## **SB 12**

### **SERVICE BULLETIN No. 12**

## **Deactivation of xenon-type strobe lights**

**Applies to Sinus/Virus/Virus SW/Taurus aircraft which were delivered before March 2011 and are equipped with NAV/Strobe wingtip lights.**

**Image 1: Aged, faulty xenon-type strobe light, which caused sparking**

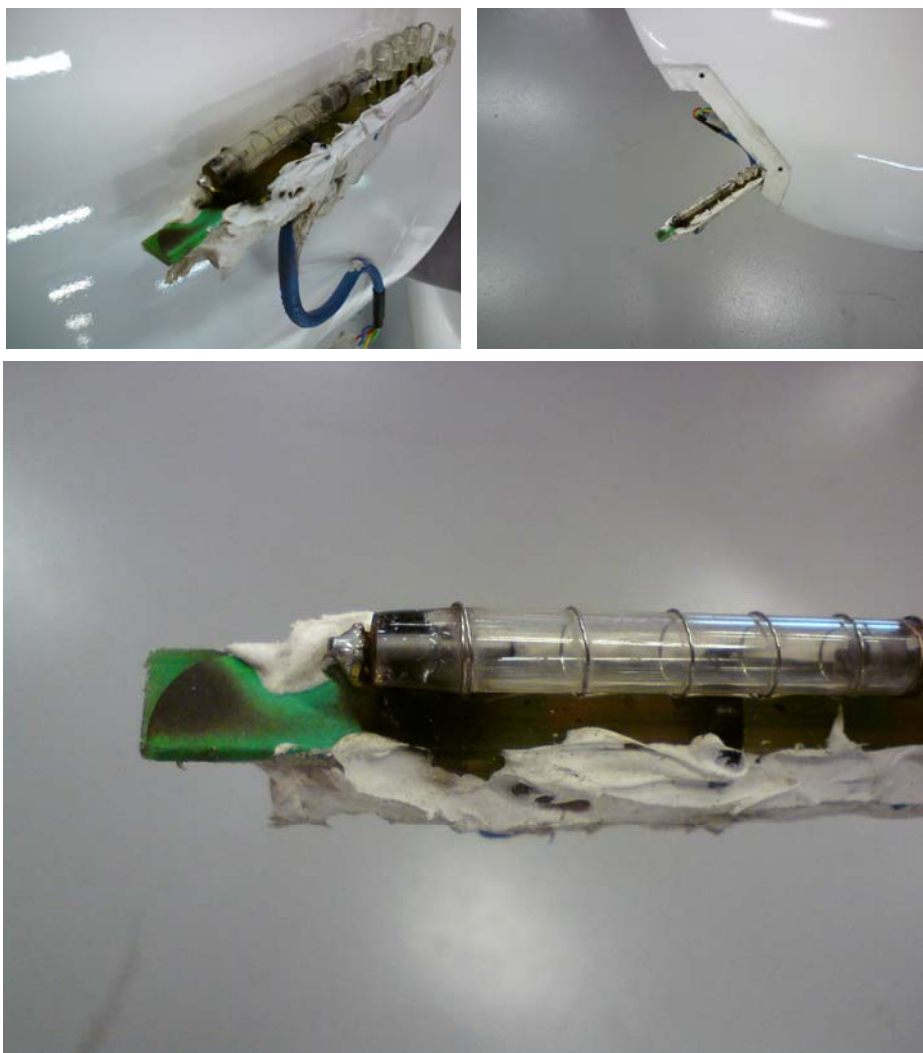
An incident occurred where the sparking from the strobe light ignited fuel fumes in/around the wing just after refueling and caused structural damage to the wing on a Sinus ultralight motorglider upon switching the lights on. The aircraft was still on the ground. The cause of the sparking was determined to be a faulty, aged, xenon-type strobe light. Upon investigation, it was discovered that large, 4 cm long sparks (1.75 inch) sparks were produced by the light unit in question.

In order to prevent eventual occurrences of sparking with other, similar type xenon-type strobe lights, used in airplanes with serial numbers listed on the cover page, it is required to disable the functioning of the strobe lights. NAV (red, green) lights in the same package are not problematic, as they are made with LED-technology.

Disable and/or remove the switch on the instrument panel, which controls the strobe lights.

Behind the cockpit, locate and remove the central unit of the NAV/Strobe lights. Use the Green and Blue wires from the wing cables to connect the NAV (LED technology) lights directly to the 12 V switch on the instrument panel. This option retains the functionality of the NAV lights and only disables the xenon-type strobes. Required work – 30 minutes, required material – AWG 18 wire approx 2 meters (6 ft), soldering gun or appropriate connectors.

Plug&play replacement packages are ready for shipping at a nominal cost for aircraft out of warranty. For aircraft still under warranty period, the replacements packages will be provided free of charge.. Instructions on installation are provided as part of the replacement package. The new lights are all-LED based, therefore no sparking can occur.
